GROUP	MODEL
Safety Recall Campaign	2011-2013MY Sportage (SL)
NUMBER	DATE
SC284SL	May 2024

### HECU MULTI FUSE REPLACEMENT (SC284SL)

This bulletin provides information to replace the multi fuse of the Hydraulic Electronic Control Unit (HECU) and install an updated junction box label on certain 2011-2013MY Sportage (SL) vehicles produced from May 6, 2010 through October 7, 2013. An engine compartment fire may occur in the area where the HECU is located. The HECU may experience an internal electrical short circuit condition that can result in overcurrent, thereby increasing the risk of an engine compartment fire while the vehicle is driven or while parked. Dealers are to install new fuses to prevent an electrical short circuit condition in the HECU's electrical circuit board. Customers may experience illumination of the Malfunction Indicator Lamp (MIL), ABS warning light, burning/melting smell, and/or smoke from the engine compartment. Follow the procedure outlined in this publication to install a new multi fuse and junction box cover label on the applicable vehicle. Before conducting the procedure, verify that the vehicle is included in the list of affected VINs.

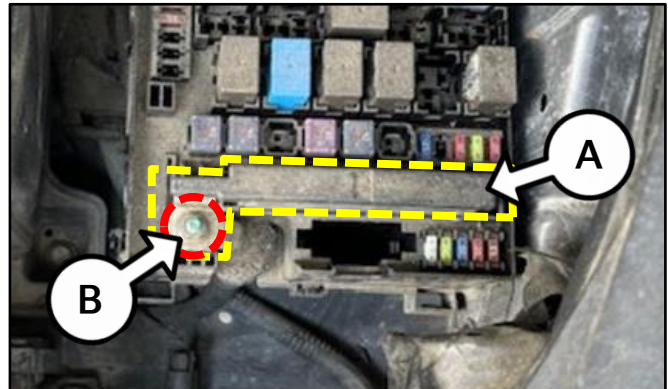
- 4a. Locate the Multi Fuse (A) for ABS1 and loosen the 10mm Multi Fuse retaining nut (B) and remove the Multi Fuse.

- 4b. Install the **new** Multi Fuse (A) and tighten the retaining nut (B).

**Tightening torque for retaining nut (B):**  
7.2 - 8.7 lb.ft (9.8 - 11.8 N.m)

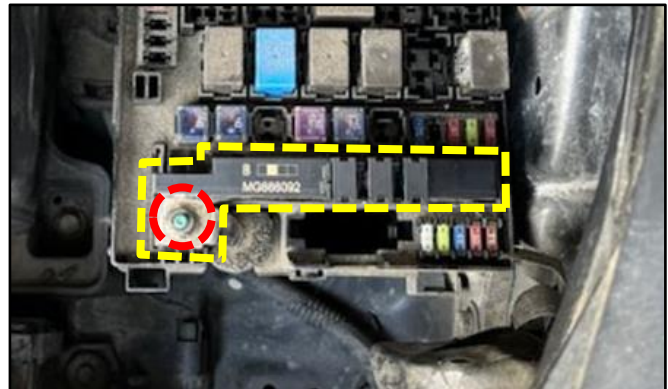
**Note:** Drill a hole through the center of the removed Multi Fuse. DO NOT reuse.

5. Adhere the new fuse label to the bottom of the **new** junction box fuse cover, as shown.
